June 15, 1984
TXX-4198

COMANCHE PEAK STEAM ELECTRIC STATION
UNITS 1 AND 2
WELDING ALLEGATIONS TRANSMITTED
BY LETTER OF APRIL 23, 1984
File No.: 10125

RESPONSE TO STAFF QUESTIONS REGARDING
INTERPASS TEMPERATURE, PREHEAT AND
PIPE SUPPORT H-CC-1-SB-038-010-3

FIGURE 1

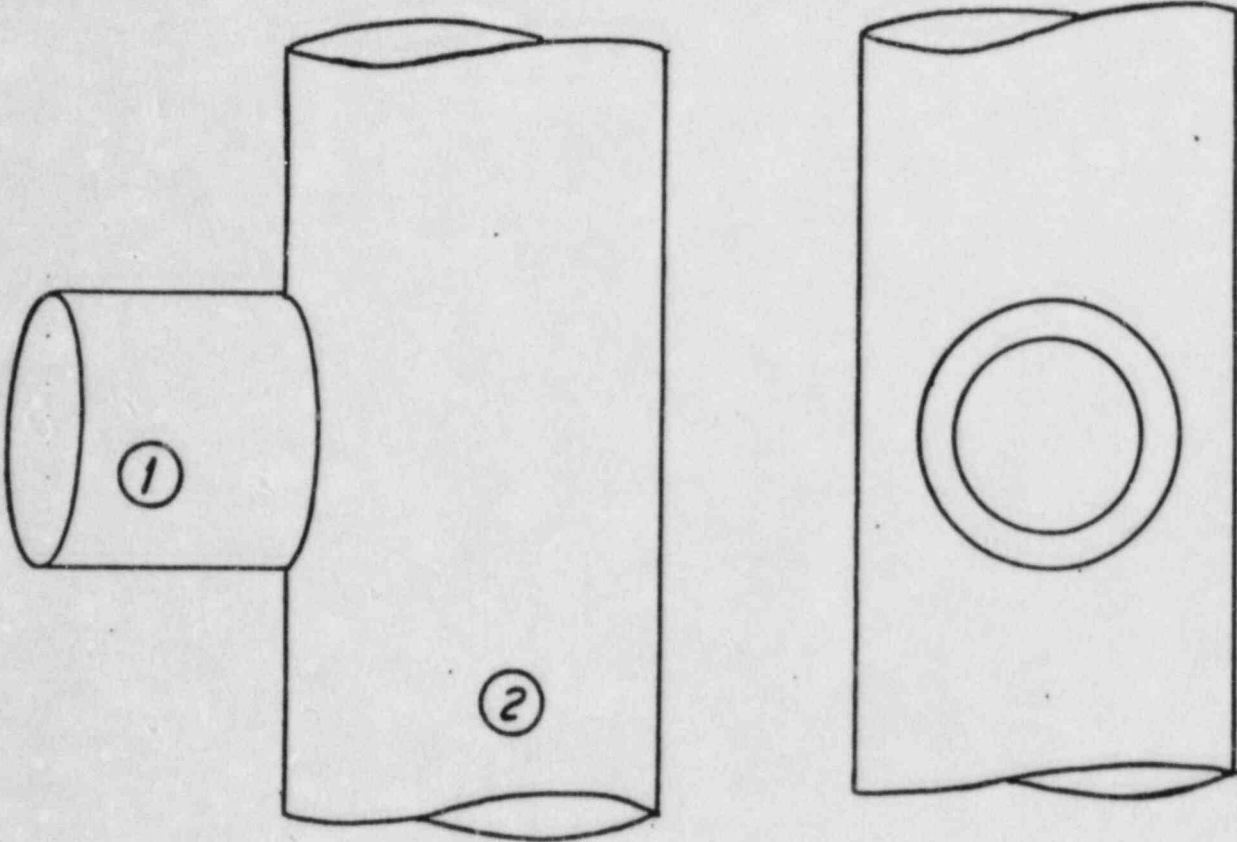
All drawings for attachments to piping requiring Charpy impact values were reviewed to obtain worst case conditions for heat input. Mock-ups simulating the three "worst case" conditions were welded in a deliberate attempt to exceed maximum interpass temperatures (see Attachment B, Figures 1-5).

Mock-up No. 1 (Figures 1 and 2 of Attachment B) simulated a pipe support with a pipe stanchion welded directly to the process pipe. The weld joint used was a full penetration groove weld in order to maximize the amount of weld metal deposited.

Mock-up No. 2 (Figures 1 and 3 of Attachment B) also simulated a pipe support with a pipe stanchion welded directly to the process pipe. The stanchion was fillet welded to the pipe (completely around).

The results of these tests showed that for Mock-up Nos. 1 and 2, interpass temperatures did not even approach the maximum interpass temperature specified in WPS 11032. For Mock-up No. 3, however, on the lug side of the joint, an interpass temperature

FIGURE 4
MOCK-UP NO.3
LUG WELDED TO PIPE

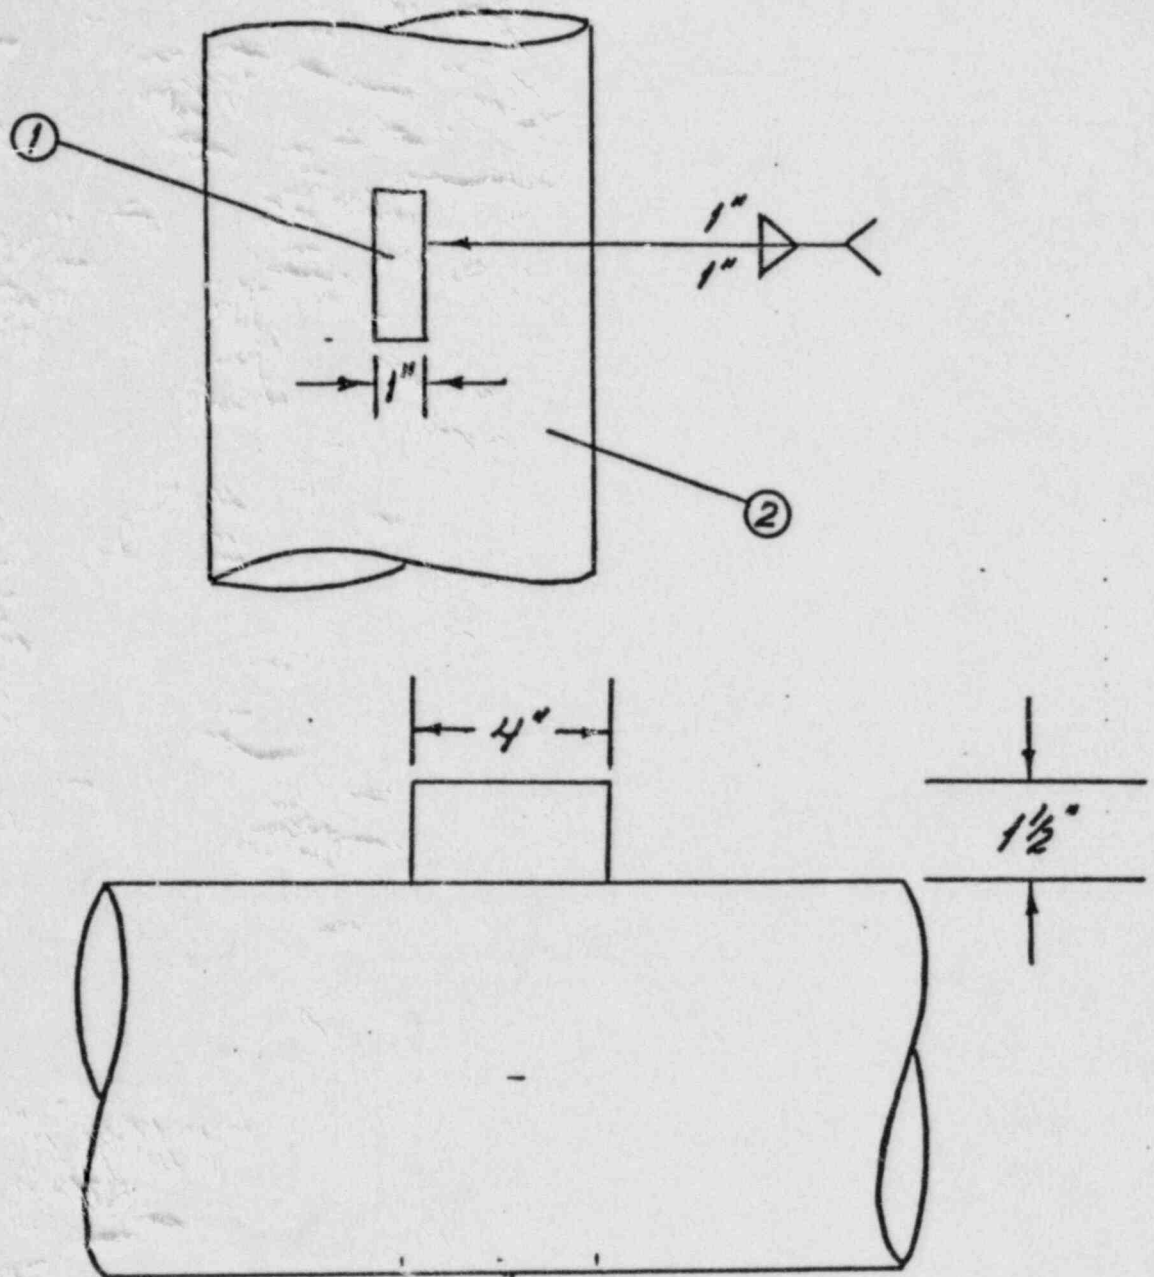
Mock-up No. 3 (Figures 4 and 5 of Attachment B) simulated a pipe support where a lug is welded to the process pipe. This configuration was selected purposely in a deliberate attempt to exceed the 500^oF interpass temperature. (The lug provides a relatively small volume of material to disperse the welding heat.)

of 650°F was recorded. (See Figure 5 of Attachment B). This temperature was achieved only after preheating the joint to 200°F, depositing beads three times as wide as permitted by WPS 11032 and violating the numerous other parameters affecting heat input.

REV	DATE	DWN	CHKD	APPR	DESCRIPTION
PROB. #	DATA PT.	DESIGN LOADS (LBS)			PIPE MVMT. (INCHES)
		SERVICE LEVEL LIMITS			
		A	B	C	
	VERT				.03
+N, E, UP	N-S	35	39	43	.00
-S, W, DN	E-W	32	36	40	.00
DRAWING NO. H-CC-1-SB-038-010-3					1 - 8HT REV. 1 - OF - 1

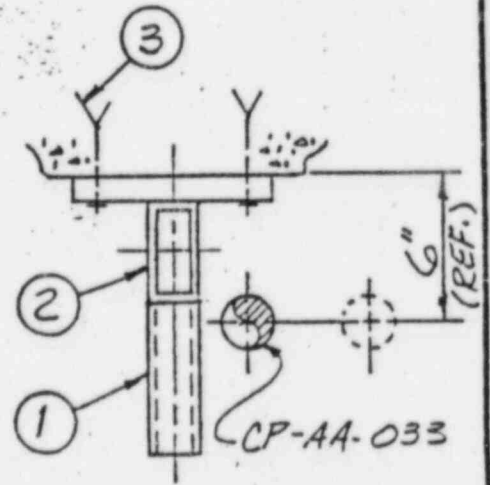
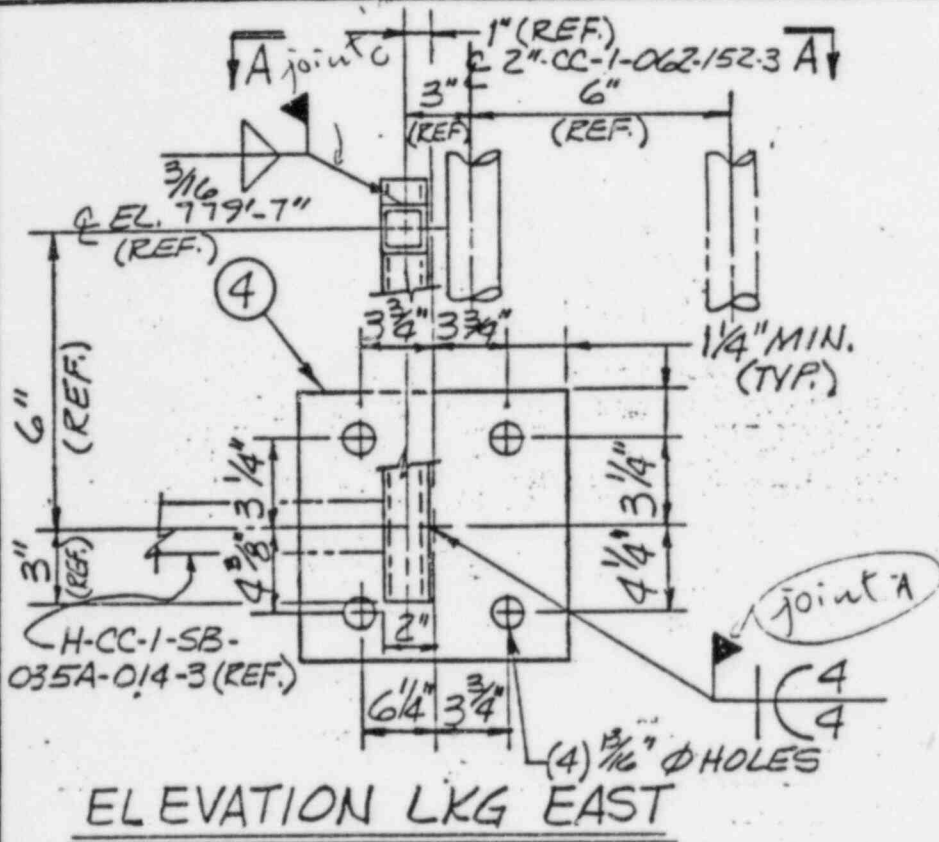
Provide an evaluation of whether this support, in its current condition, is satisfactory for service. Your answer should provide a detailed technical basis for your conclusion, along with any necessary supporting documentation.

The two welds on the subject support (the concern giving rise to this question) have been inspected and accepted by QC. Further, an analysis of the two welds has been performed (Attachment C) which demonstrates that the two welds are loaded only to 3 and 7.4 percent of capacity. In view of the acceptable condition of the welds as documented by a QC inspection and the analysis which shows that the loads on these welds are extremely small, no further evaluation or testing is warranted.
